# Access Compliance Report

## Public Rights-of-Way

### (Curb Ramps)

Intersection ID: 7725	Main Street: HIDDEN_VALLEY_RD	Cross Street: W_SUGAR_CREEK_RD	Location: SE
ADA ID: AB8AE56680C1	Ramp Type: ParaDiag	Initial Pass/Fail: Fail	Overall Compliance: No
Severity Score: 21.25			
Codes/Mitigation Info/Possible Solution		Field Measurements/Component Compliance

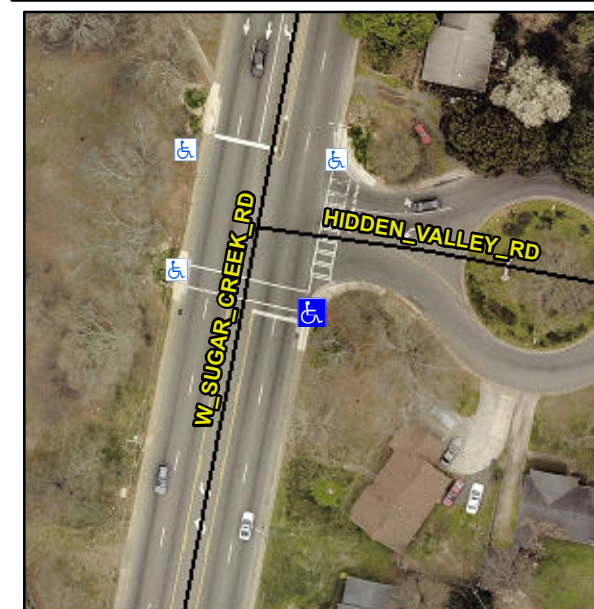
**LT RP < 5%**

**R304.5.1, R304.3.2**

Compliance	Description	Data	Compliance	Description	Data
N/A	Ramp Length LT (in)	63.0	N/A	Ramp Length RT (in)	61.0
No	Ramp Width LT (in)	47.5	No	Ramp Width RT (in)	47.5
Yes	Ramp Slope LT (%)	0.8	No	Ramp Slope RT (%)	8.7
Yes	Ramp XSlope LT (%)	0.8	Yes	Ramp XSlope RT (%)	1.9
N/A	Landing Length (in)	N/A	N/A	DWS Provided?	N/A
N/A	Landing Width (in)	N/A	N/A	DWS Contrast?	N/A
N/A	Landing Slope (%)	N/A	N/A	DWS Length (in)	N/A
N/A	Landing X Slope (%)	N/A	N/A	DWS Full Width?	N/A
N/A	Landing Curb? (Y/N)	N/A	N/A	DWS Offset (in)	N/A
N/A	Shared Landing?	N/A			
N/A	Gutter Ponding?	N/A	N/A	Gutter Slope (%)	N/A
N/A	Gutter Lip Ht (in)	N/A	N/A	Gutter X Slope (%)	N/A
N/A	Painted X Walk1?	Yes	N/A	Painted X Walk2?	Yes
	X Walk 1 Direction	To N		X Walk 2 Direction	To W
N/A	X Walk 1 Width (in)	111.0	N/A	X Walk 2 Width (in)	120.0
	X Walk 1 Slope (%)	2.6		X Walk 2 Slope (%)	2.6
	X Walk 1 X Slope (%)	2.0		X Walk 2 X Slope (%)	2.5
N/A	Ramp inside XWalk1?	Yes	N/A	Ramp inside XWalk2?	Yes

**Remove & Replace Curb Ramp With Two New Directional Ramps or Equivalent.**
